IAEWESTWIND

SERVICE BULLETIN

1124 SERVICE BULLETIN INDEX

FIGURE 1

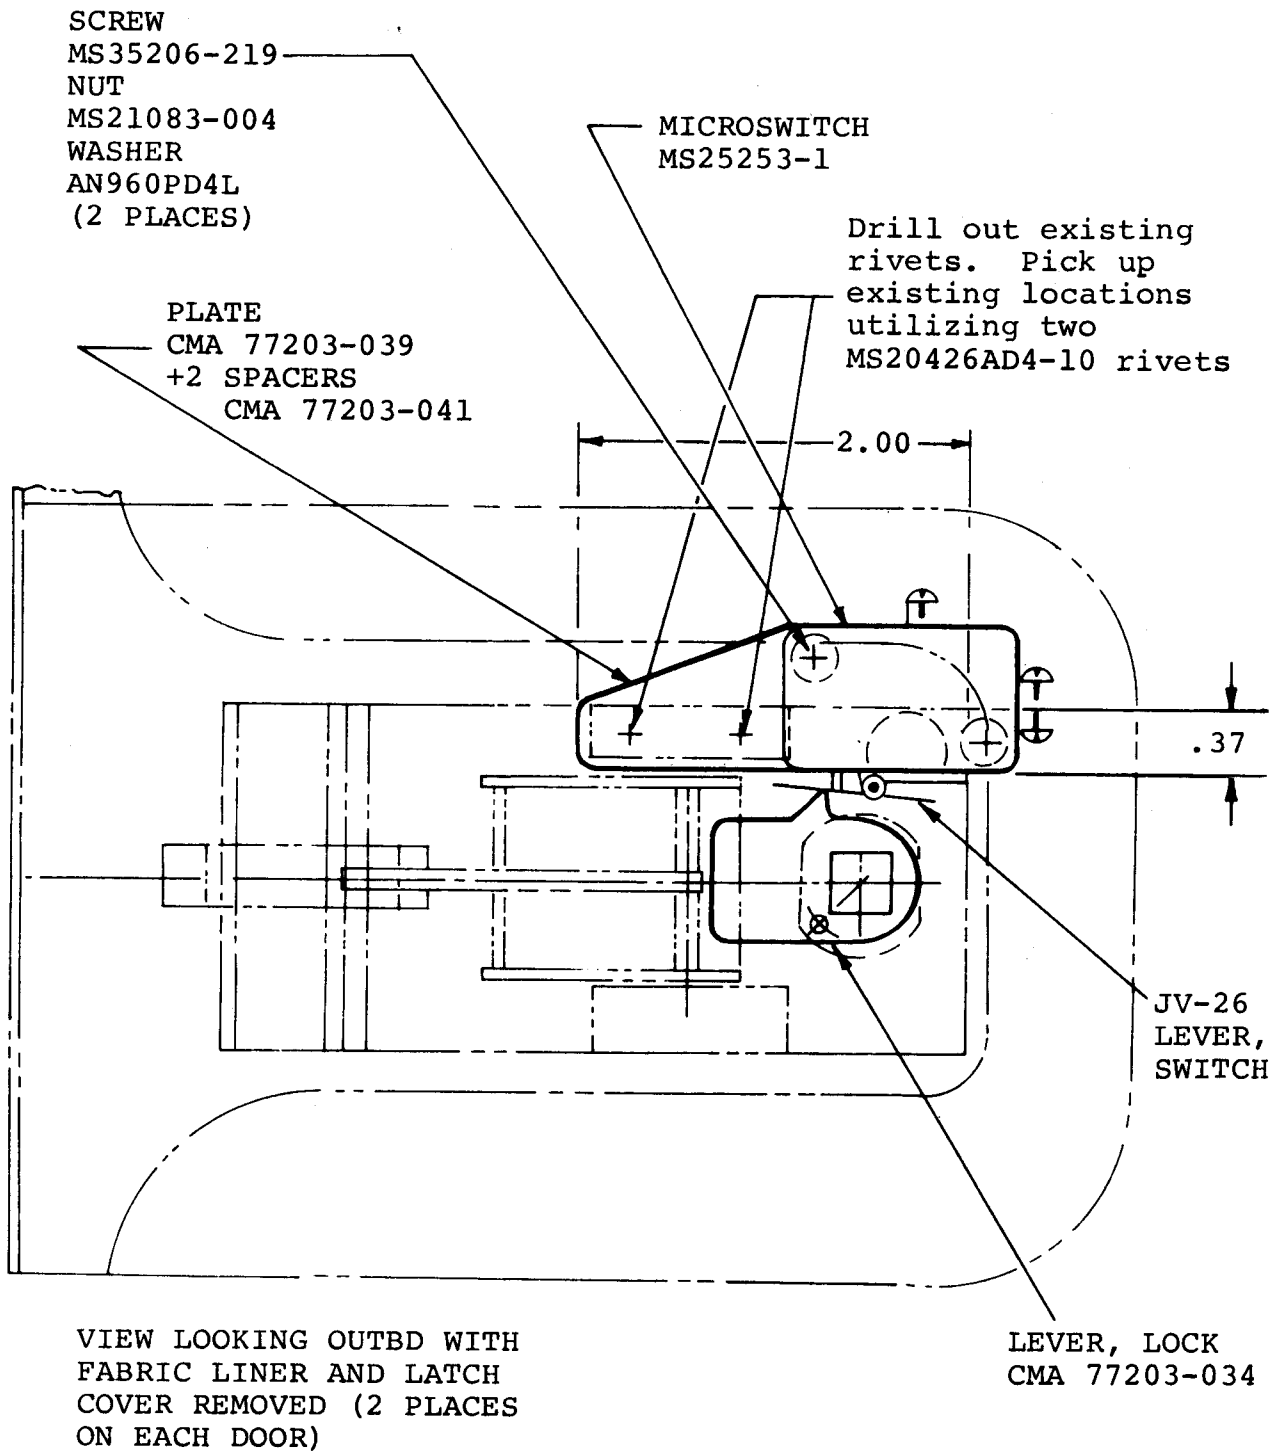
- F. Locate and drill two holes in the new CMA 77203-039 mounting plate as shown in Figure 1.
- G. Before installing the two new mounting plates, insert a CMA 77203-041 spacer in each of the existing counterbored holes in the upper hinge blocks. Install the new CMA 77203-039 mounting plates on the two upper hinge blocks (using existing rivet holes) and rivet in place utilizing MS2042AD4-10 rivets. (See Figure 2).

FIGURE 1

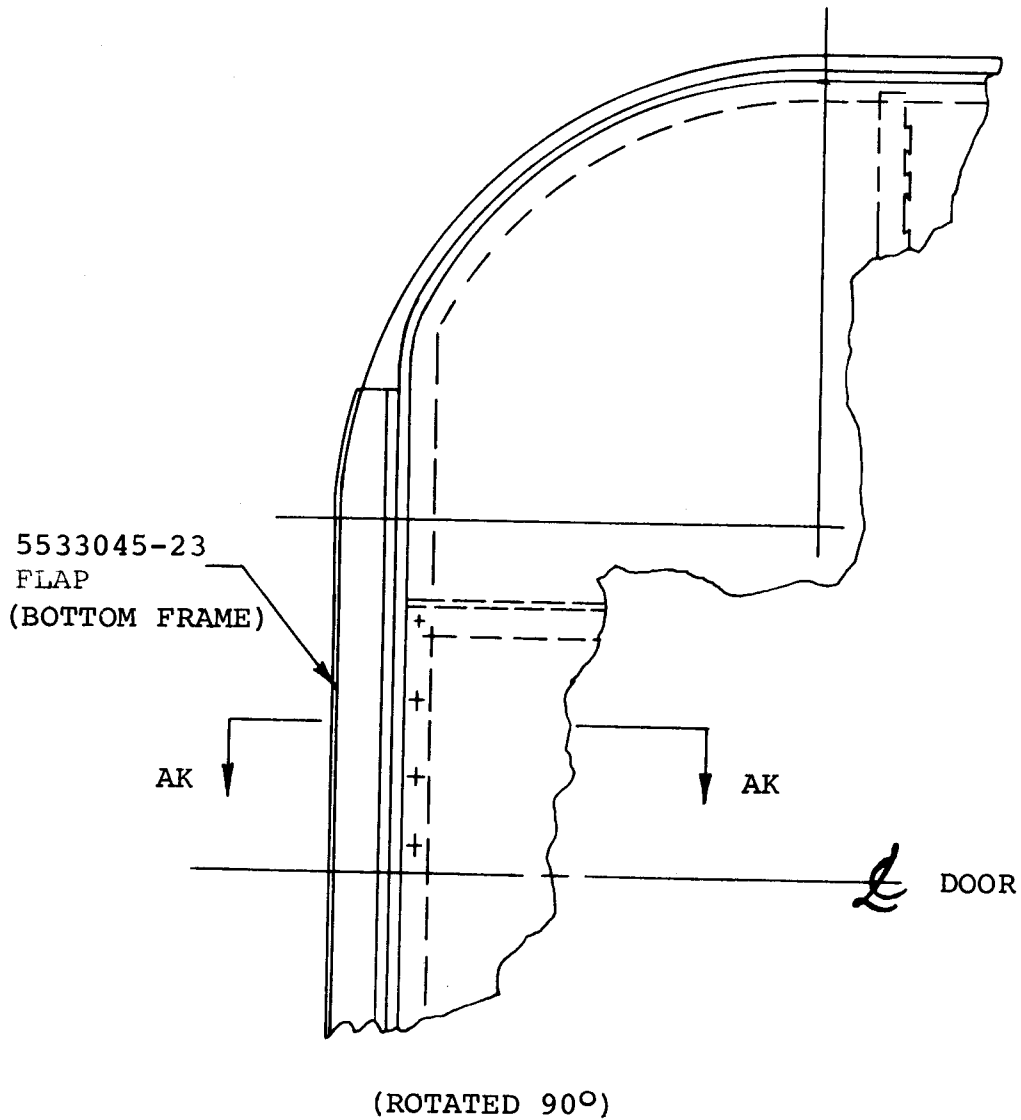
1124 Maintenance Manual, Chapter 52-10-00, page 1.
1124 Illustrated Parts Catalog, Chapter 52-10-00, page 1.
Figure 1.

Figure 2

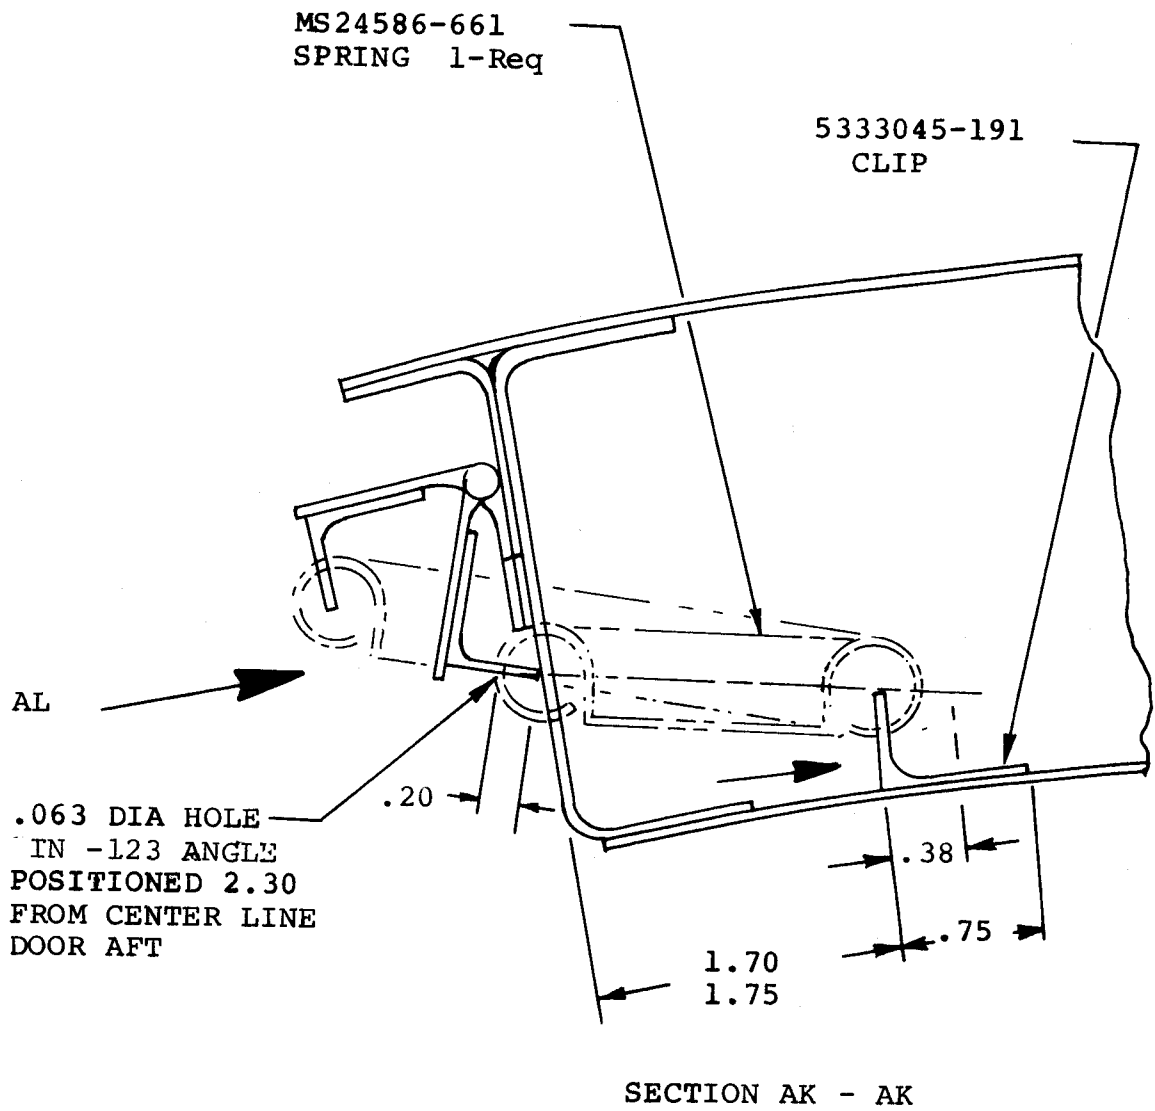
- A. Remove cabin door interior lining, including ice chest and bar if applicable.
- B. Using the measurements as outlined in Figure 3, locate and cut a hole in bottom door frame.
- C. Secure clip (5333045-191) by riveting (2 pls) to the inner door structure, using the dimension outlined in Figure 2 and Figure 3.

- D. Drill a .063 diameter hole in the flapper angle to align with the hole cut in the door frame (Step B) Refer to Figure 2 for dimensions.
- E. Attach spring to the clip and flapper angle. Check for sufficient clearance between spring and door structure.
- F. Reinstall cabin door interior which was removed in Step A.

FIGURE 1 DOOR-STAY EYE-BOLT RELOCATION

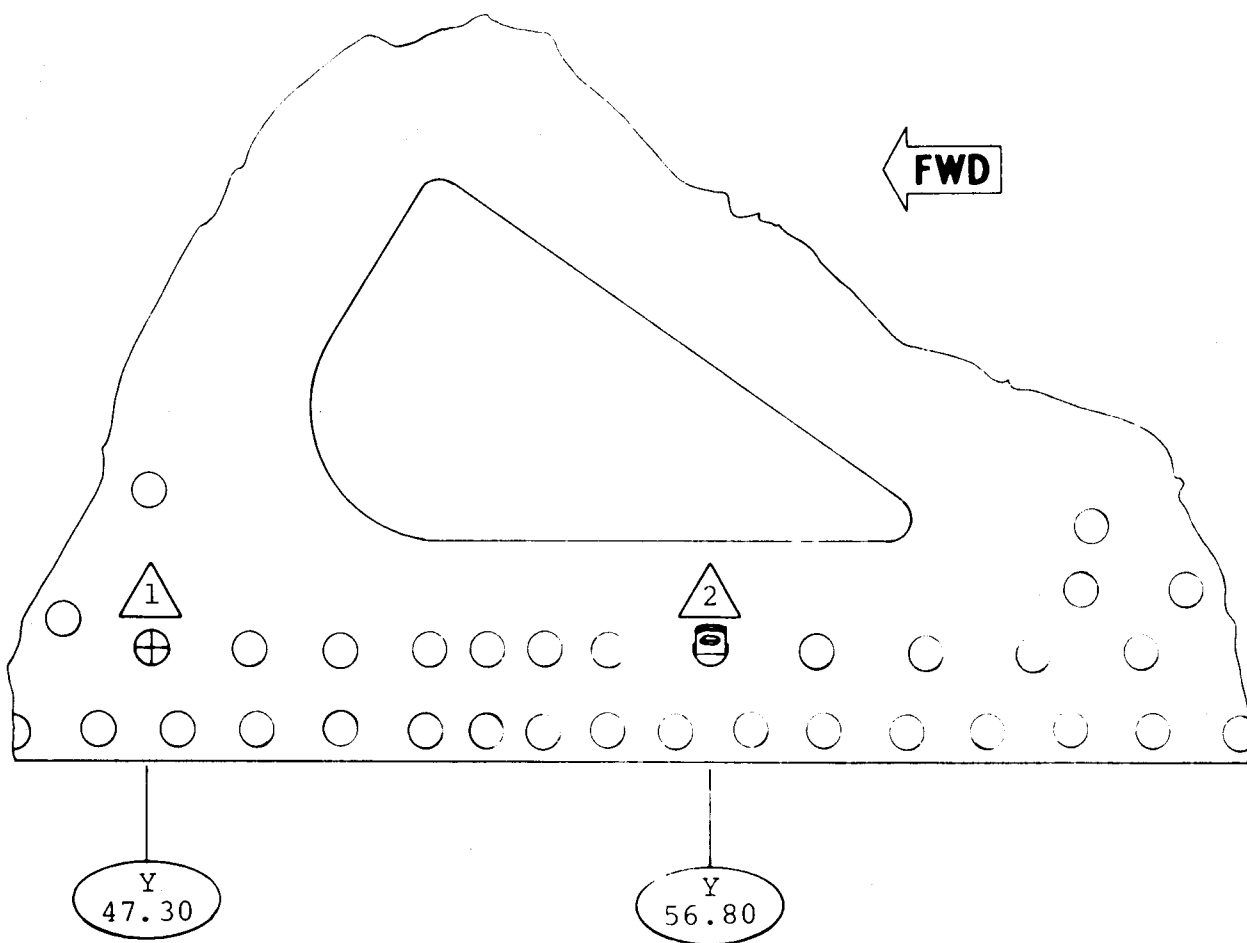
- A. Remove inside door trim panel.
- B. Remove pilot's seat and cockpit interior trim panel just below DV window.
- C. Move eye-bolt P/N 5123617-15 from its existing location to position shown in Figure 1. Plug old hole with screw removed to install eye-bolt in new location.
- D. Remove chain bushing P/N 5123617-13, reel assembly P/N 5123617-7, and bracket assembly 5123617-5 from entrance door and discard.
- E. Locate doubler P/N 5123617-RE3 per Figure 3 and drill eight #30 (.128 inch dia.) holes.
- F. With doubler secured in place, temporarily locate and drill 1.12 inch dia. hole through door and doubler. Ref. Figure 3.
- G. Slide door-stay assembly into door, locate and drill two #10 (.193 inch dia.) mounting holes.

1. REMOVE EYE BOLT P/N5123617-15 AND RELOCATE BETWEEN STATION Y-53.00 & Y-56.80 ACCORDING TO MAXIMUM OPEN POSITION. USE ONE OF EXISTING SCREWS LOCATED BETWEEN THESE STATIONS.

2. REMOVE SCREW AND RELOCATE TO STATION Y-47.30 WHERE EYE-BOLT WAS REMOVED

FIGURE 2 DOUBLER AND DOOR-STAY INSTALLATION

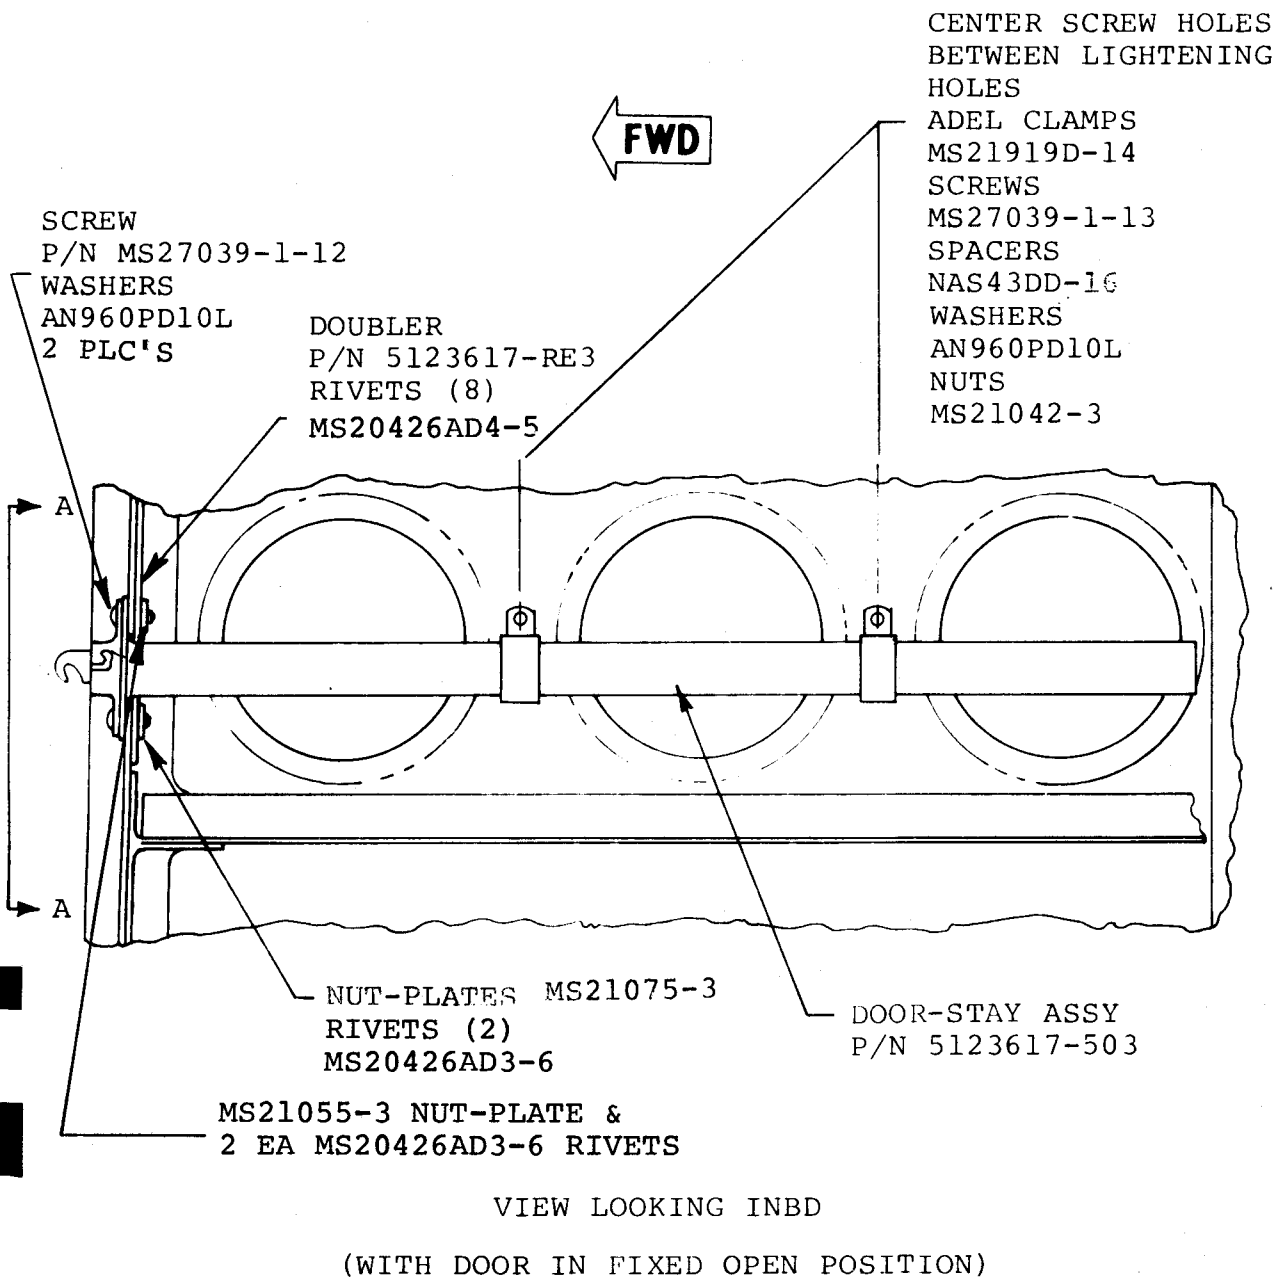
- M. Drill two #10 (.193 inch dia.) holes midway between lightening holes to secure Adel clamps. Ref. Figure 2.
- N. Install two MS21919DG-14 Adel clamps with MS27039-1-13 screws, NAS43DD-20 spacers, two AN960PD10L washers and MS21042-3 nuts, (supplied with door-stay Ass'y).

FIGURE 3 DOUBLE AND DOOR-STAY INSTALLATION

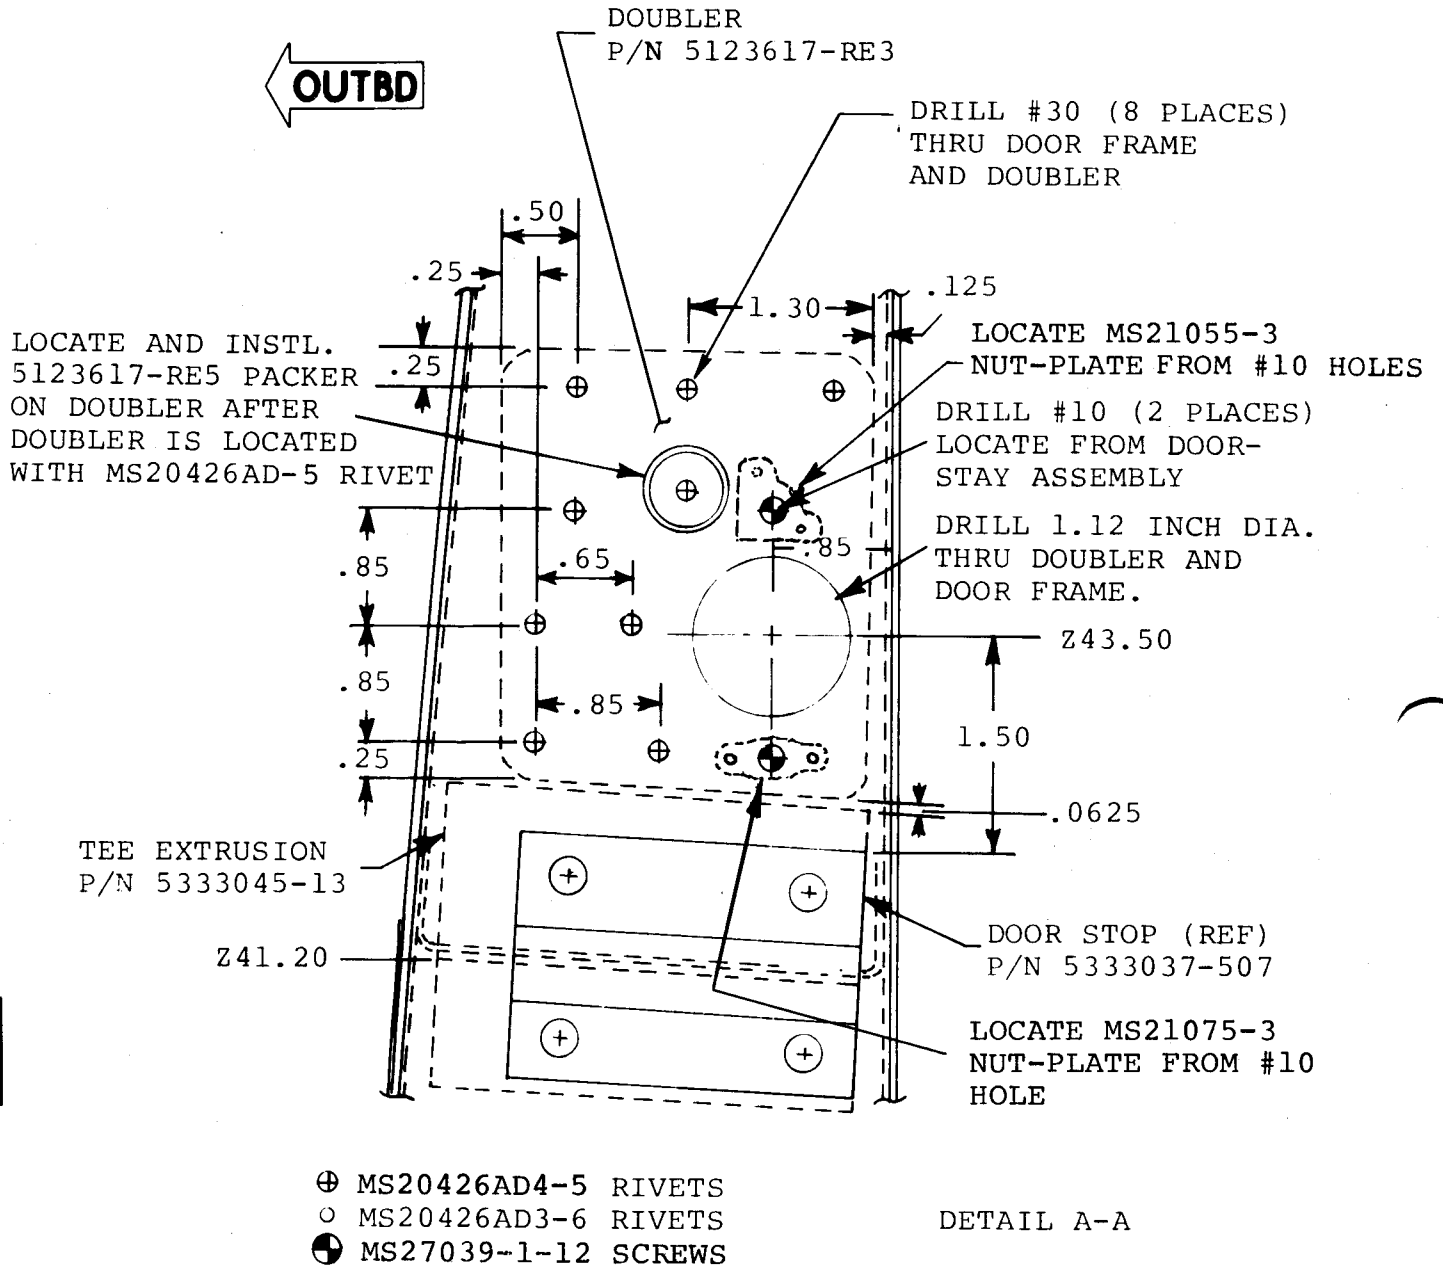
- H. Remove stay assembly, locate nut-plates and drill #40 (.098 inch dia.) holes for mounting nut-plates with four (4) MS20426AD3-6 rivets. Ref. figure 3.
